STATE OF WASHINGTON
DEPARTMENT OF ECOLOGY

September 20, 2011

Re: Opinion on Proposed Cleanup of a Property associated with a Site (Penthouse Drapery Cleaners and Manufacturers, Inc):

- Address: 1752 Rainier Ave. S., Seattle, WA
 - Facility/Site No.: 23408
 - VCP No.: NW 2278
- CSIO # 3184

SITE BOUNDARY

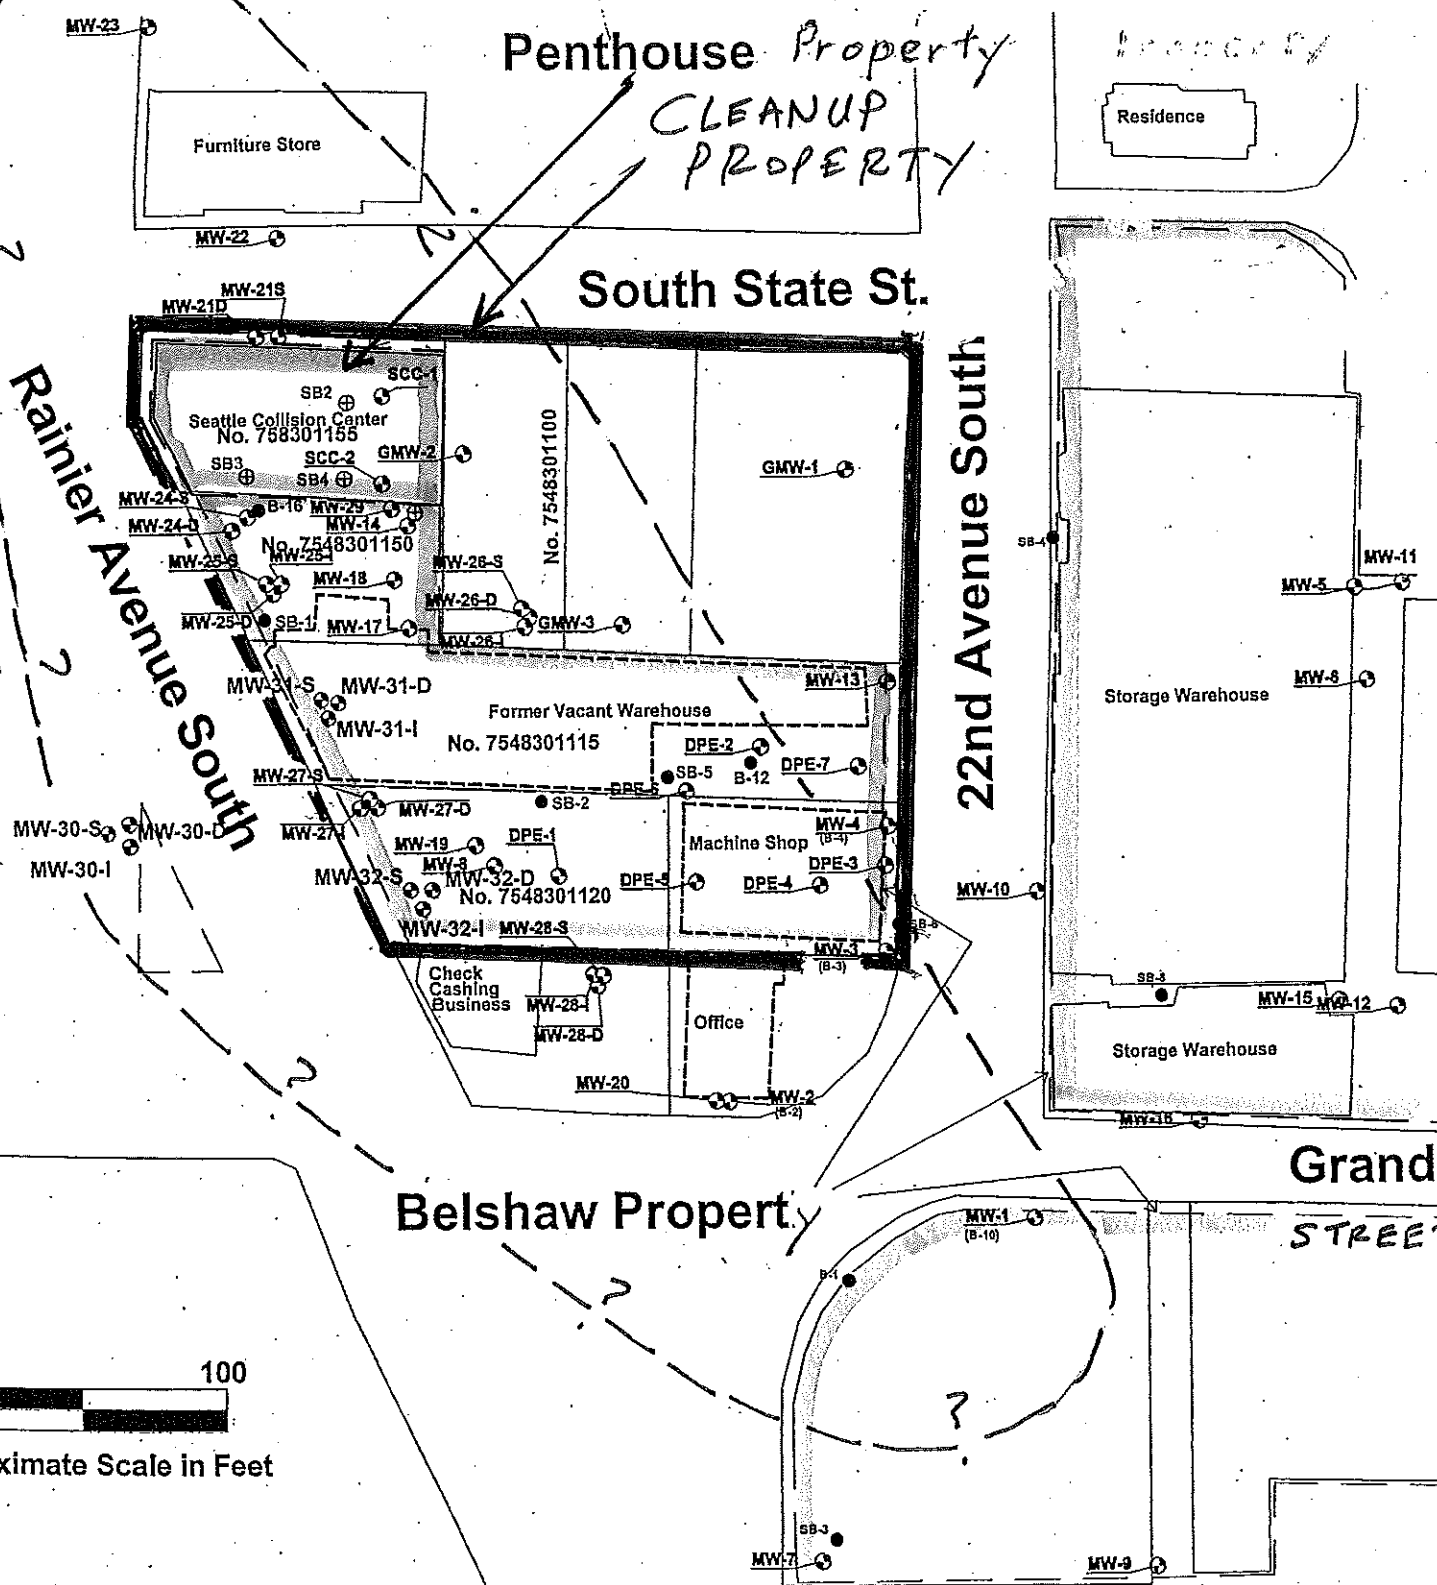
The "Site" is the volumetric area that has been contaminated, and is defined primarily by PCE in soil, ground water, and air. TCA is also present in ground water, along with the PCE-breakdown products TCE and DCE. The estimated areal extent of the Site is shown on the attached Site Map. As illustrated, the Site includes the entire Penthouse property, portions of the adjoining properties to the north, south, and east, and a likely westward extension into the Rainier Avenue South right-of-way. The Site also appears to extend southward and eastward beyond Grand Street, based on PCE, TCE, and DCE detections in wells MW-1, MW-2, and MW-20.

Release and Extent of Contamination - Soil: PCE contamination in soil extends to depths of greater than 70 feet below land surface (the full depth has not been determined) in the source area at the Penthouse property. The affected area appears to be on the order of 100 by 100 feet in plan dimension, although it may extend further to the east and west where the boundaries of the contaminated area have not been defined. Contaminated soil also extends more than 100 feet to the southeast (the southern edge has not been defined), associated with the PCE contaminant plume in ground water (see below). Soil PCE concentrations in this down gradient area are considerably less than in the source area.

Extent of Contamination – Ground Water: Extensive ground water monitoring data show a PCE plume extending southeastward over 350 feet from the source area. The PCE contamination is present in all of the water bearing zones, and declines from near-free-product-level concentrations directly at the source to a few parts per billion at the distal edge of the plume.

The boundary of the contaminant plume within the three or four water bearing zones has been largely determined to the east and north, but not to the southeast, southwest, or west. The base of contaminant plume has also not been determined.
